**AMENDMENTS TO THE DRAWINGS**

### REMARKS

THIS IS AN ATTACHMENT TO THE  
 AMENDMENT, NOT A REPLACEMENT  
 DRAWING SHEET

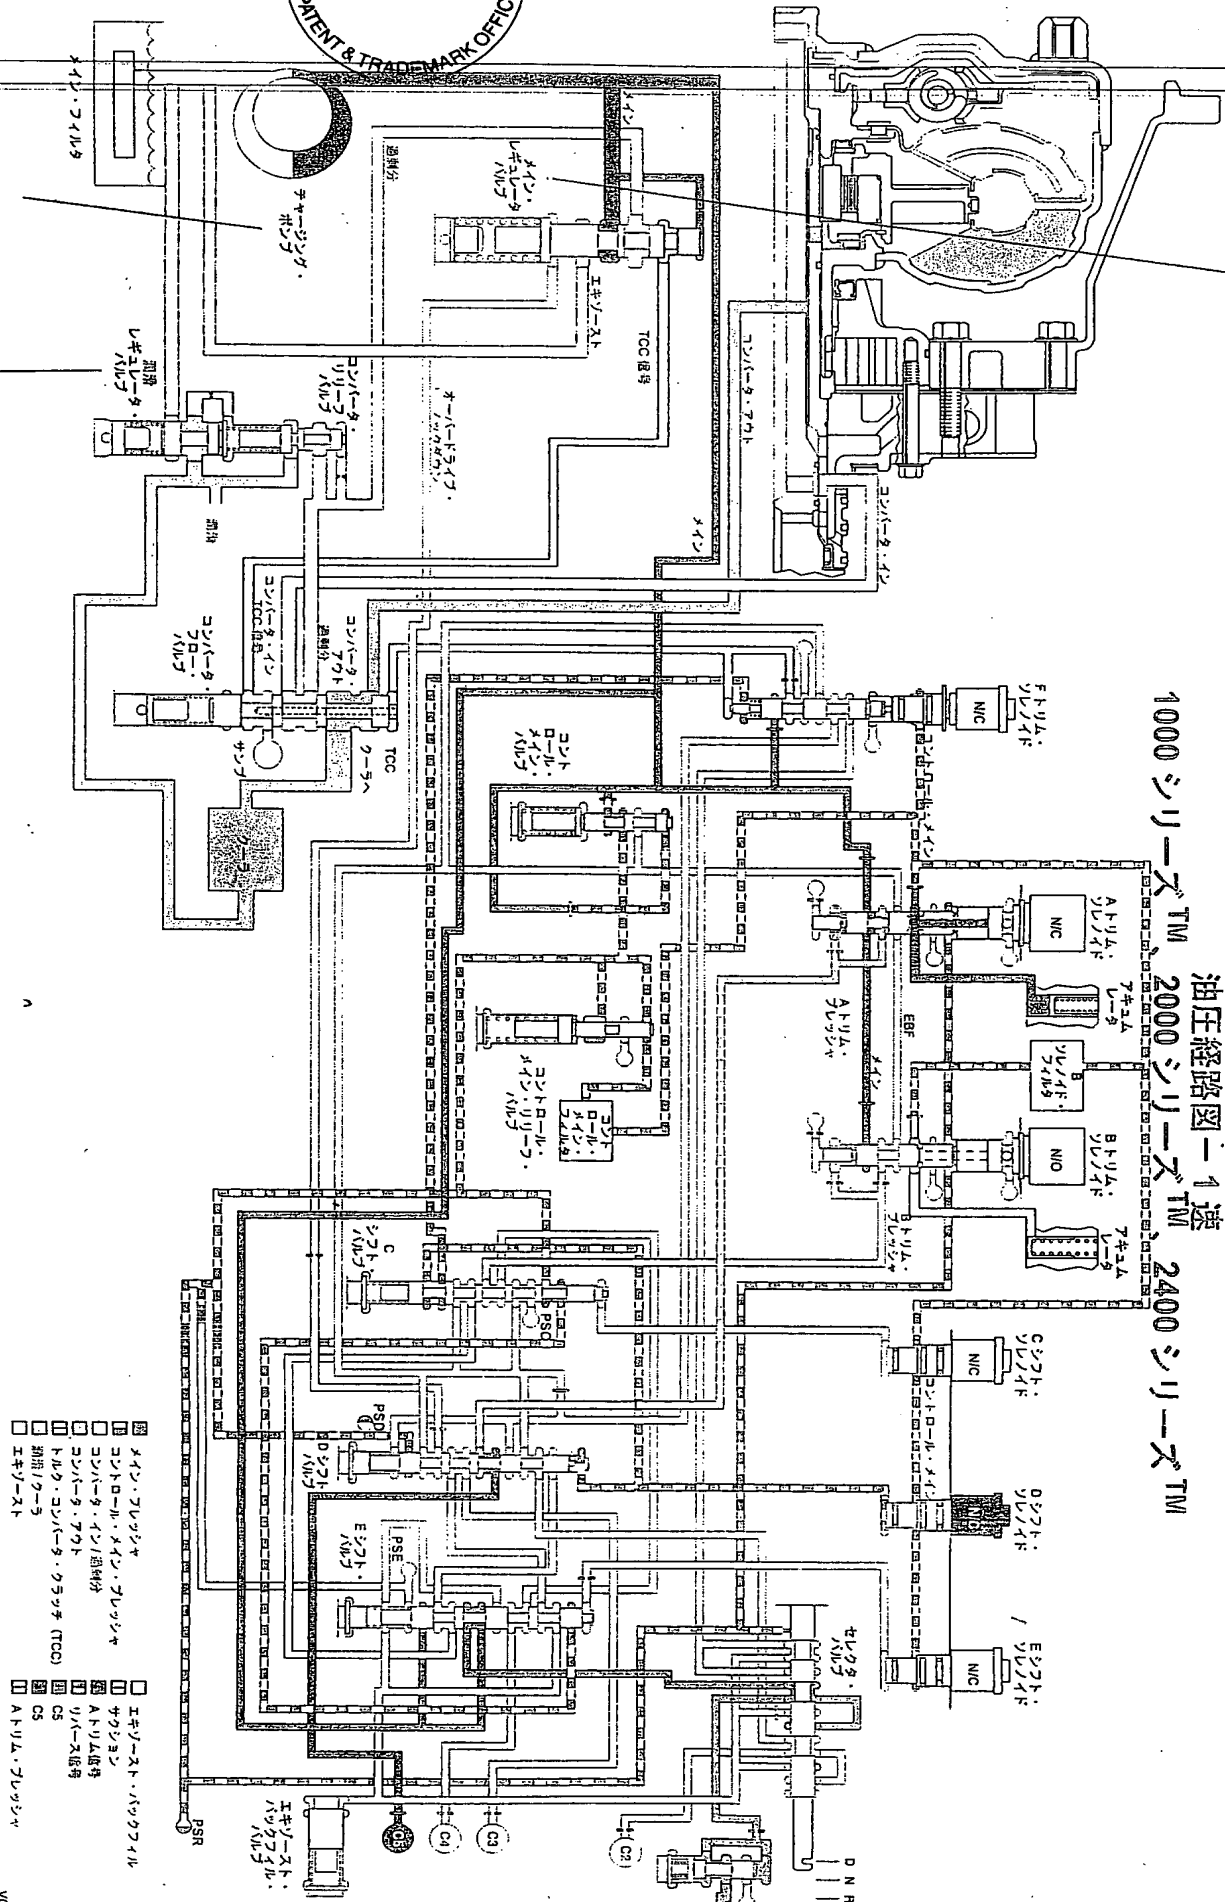
The Official Action sets forth a claim rejection based on the first paragraph of 35 U.S.C. § 112, first paragraph. This rejection is based on the claim wording reciting the first and second regulators. These regulators are simply the known regulator valves commonly used in automatic transmission oil pumps. It is respectfully submitted that one of ordinary skill in the art familiar with automatic transmission oil pumps would readily understand the function and purpose of these regulators. It is noted that the description of the known automatic transmission oil pump set forth in the background portion of the present application also refers to the same regulators. These regulators valves are described in the publication mentioned in the third full paragraph on page two of the application, a copy of which is provide as an attachment to this Amendment. As indicated in this publication, the regulator from which excess oil is returned to the first oil passage by way of the second oil passage (i.e., the first regulator) simply refers to the main regulator valve of the automatic transmission, while the regulator from which excess oil is returned to the pump suction port by way of the third oil passage (i.e., the second regulator) simply refers to the lubrication regulator valve of the automatic transmission. Because the function and purpose of these regulators is know to persons of ordinary skill in this art, it is respectfully submitted that it is not necessary to provide a detailed description of such aspects of the automatic transmission oil pump. Stated differently, and as recognized in § 2164.05(a) of the Manual of Patent Examining Procedure, the specification need not describe what is well known to those of ordinary skill in the art. Accordingly, withdrawal of the claim rejection based on the first paragraph of 35 U.S.C. § 112 is respectfully requested.

main regulator valve

oil pump  
 lubrication regulator valve
